# Access Compliance Report

## Public Rights-of-Way (Curb Ramps)

Intersection ID: 53894	Main Street: INVERNESS_BAY_RD	Cross Street: PERTH_MOOR_RD	Location: SE
ADA ID: 65F5566183D7	Ramp Type: Perpendicular	Initial Pass/Fail: Fail	Overall Compliance: No
			Severity Score: 21.25

### Codes/Mitigation Info/Possible Solution

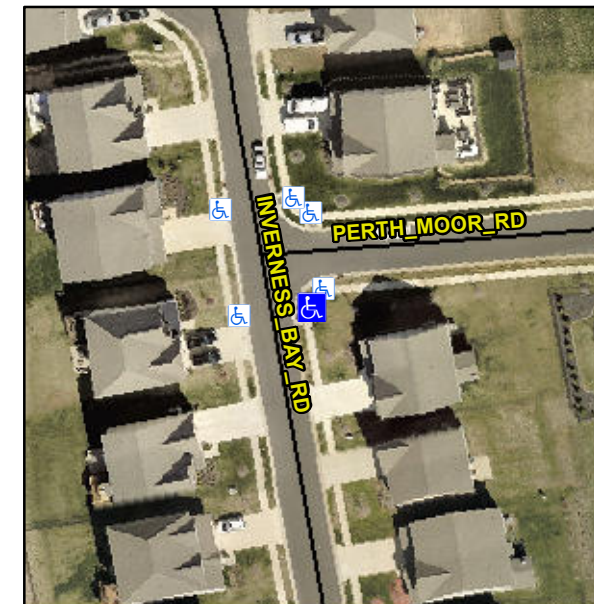
**Not Found, R304.5.1, R304.2.2**

Compliance	Description	Data	Compliance	Description	Data
N/A	Ramp Length (in)	45.0	No	Ramp Slope (%)	8.5
No	Ramp Width (in)	47.5	Yes	Ramp XSlope (%)	0.4
N/A	Flare Type LT	N/A	N/A	Flare Type RT	N/A
N/A	Flare Slope LT (%)	N/A	N/A	Flare Slope RT (%)	N/A
N/A	Flare Traversable LT?	N/A	N/A	Flare Traversable RT?	N/A
N/A	Landing Length (in)	N/A	N/A	DWS Provided?	N/A
N/A	Landing Width (in)	N/A	N/A	DWS Contrast?	N/A
N/A	Landing Slope (%)	N/A	N/A	DWS Length (in)	N/A
N/A	Landing X Slope (%)	N/A	N/A	DWS Full Width?	N/A
N/A	Landing Curb? (Y/N)	N/A	N/A	DWS Offset (in)	N/A
N/A	Shared Landing?	N/A			
N/A	Gutter Ponding?	N/A	N/A	Gutter Slope (%)	N/A
N/A	Gutter Lip Ht (in)	1.5	N/A	Gutter X Slope (%)	N/A
N/A	Painted X Walk1?	No	N/A	Painted X Walk2?	N/A
	X Walk 1 Direction	To W		X Walk 2 Direction	N/A
N/A	X Walk 1 Width (in)	N/A	N/A	X Walk 2 Width (in)	N/A
	X Walk 1 Slope (%)	3.1		X Walk 2 Slope (%)	N/A
	X Walk 1 X Slope (%)	0.2		X Walk 2 X Slope (%)	N/A

**Remove & Replace Entire Ramp.**
